Donald C. Cook Nuclear Plant Units 1 and 2  
REVIEW OF FOUR PRELIMINARY ACCIDENT  
SEQUENCE PRECURSOR ANALYSES OF OPERATIONAL EVENTS AND  
REVIEW OF DRAFT NUREG "ASSESSMENT OF RISK SIGNIFICANCE  
ASSOCIATED WITH ISSUES IDENTIFIED AT D. C. COOK NUCLEAR  
POWER PLANT"

ATTACHMENT TO C0800-15

NRC LETTER "FOUR PRELIMINARY ACCIDENT SEQUENCE PRECURSOR  
ANALYSES OF OPERATIONAL EVENTS AT D.C. COOK NUCLEAR PLANT"

DRAFT NUREG ENTITLED "ASSESSMENT OF RISK SIGNIFICANCE  
ASSOCIATED WITH ISSUES IDENTIFIED AT D.C. COOK NUCLEAR PLANT"

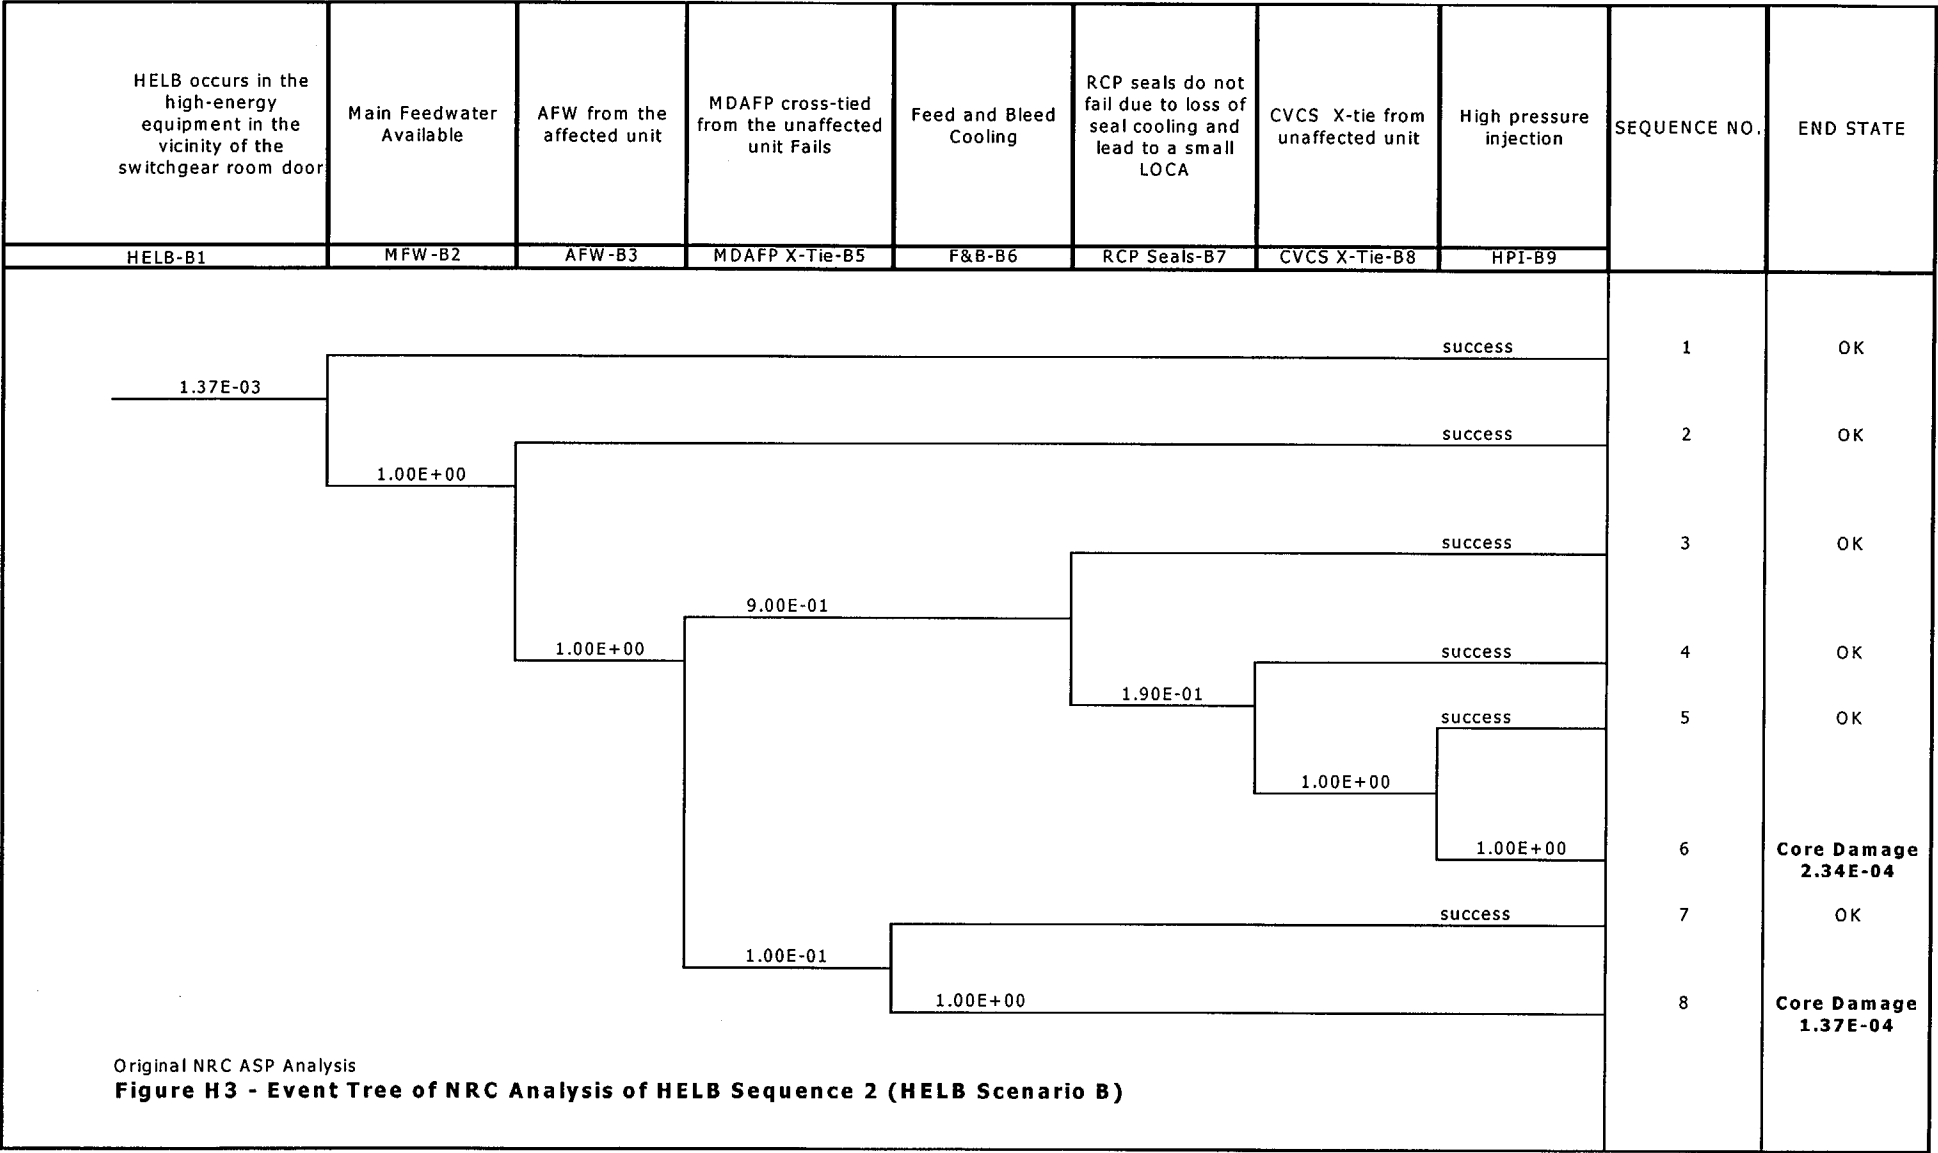
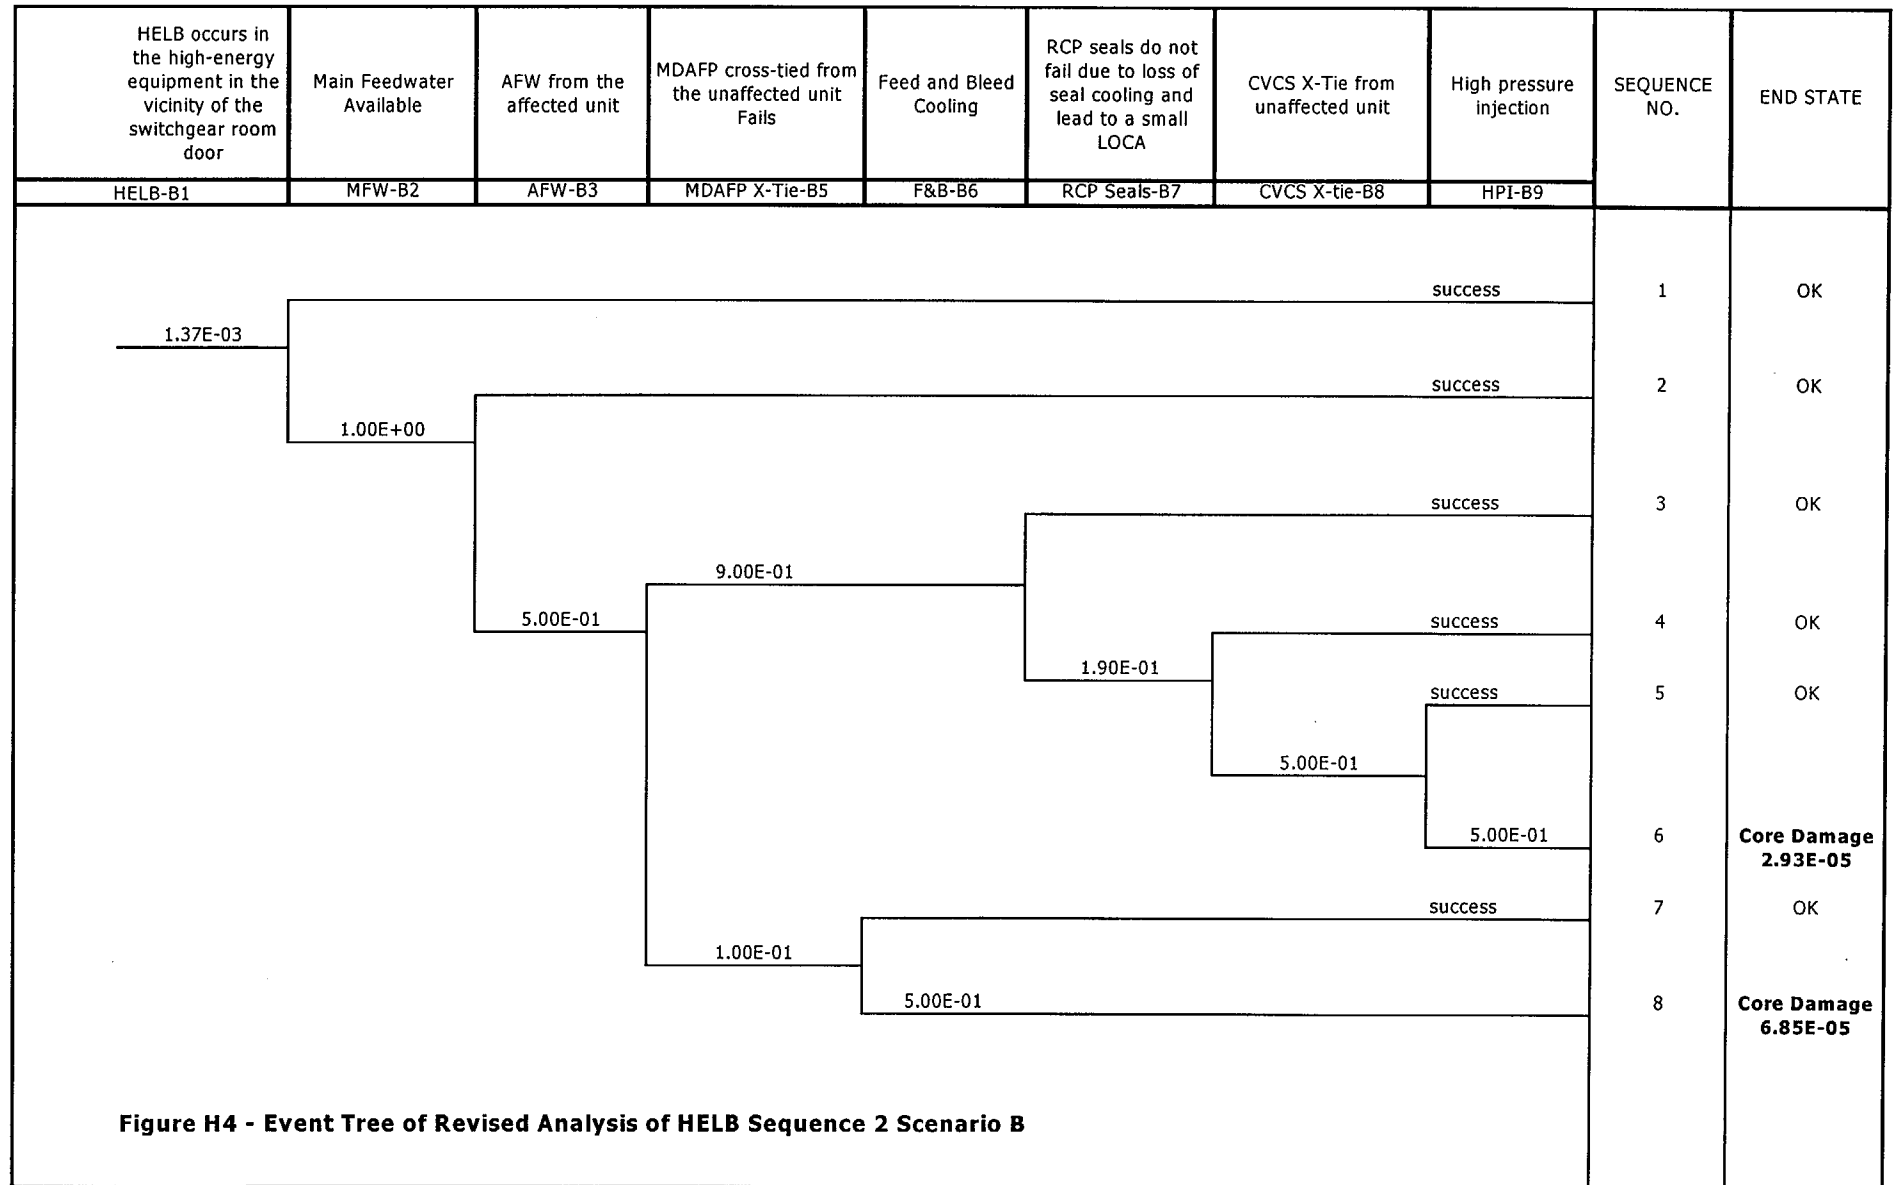
Sequence 5 describes a HELB that occurs in or near the steam generator blow-down flash tank. The following comments apply to Pages 14-15 in the discussion of Issue #122 in References 1 and the draft NUREG.

This sequence did not exceed the threshold; however, a potential error that could result in an order of magnitude change to the result is noted below.

The frequency of event E1 (HELB occurs in or near steam generator blowdown flash tank room) is estimated as  $1.6 \times 10^{-2}$ /year, and the frequency is identified on Page 14 as that which is used in Sequence 2. However, this event does not appear in Sequence 2. Also, in the calculation of the frequency of Sequence 5 on page 15, it appears that the value of  $1.7 \times 10^{-2} \times 0.79 = 1.34 \times 10^{-2}$  is used. However, the Sequence 2 frequency of HELB is given on Page 6 as  $(12.5/1200/6) \times 0.79 = 1.37 \times 10^{-3}$ , which is a change in order of magnitude. If the actual Sequence 2 value is used to replace the value of  $1.34 \times 10^{-2}$ , the CDF changes from  $1.29 \times 10^{-8}$  to  $1.31 \times 10^{-9}$ .

In the initiating event frequency, Paragraph E.1, Page 14 of Issue #122, the value of the frequency used in Sequence 2 ( $1.6 \times 10^{-2}$ ) could not be validated. Also, a different value ( $1.7 \times 10^{-2}$ ) for this frequency was used in the calculation on the following page.
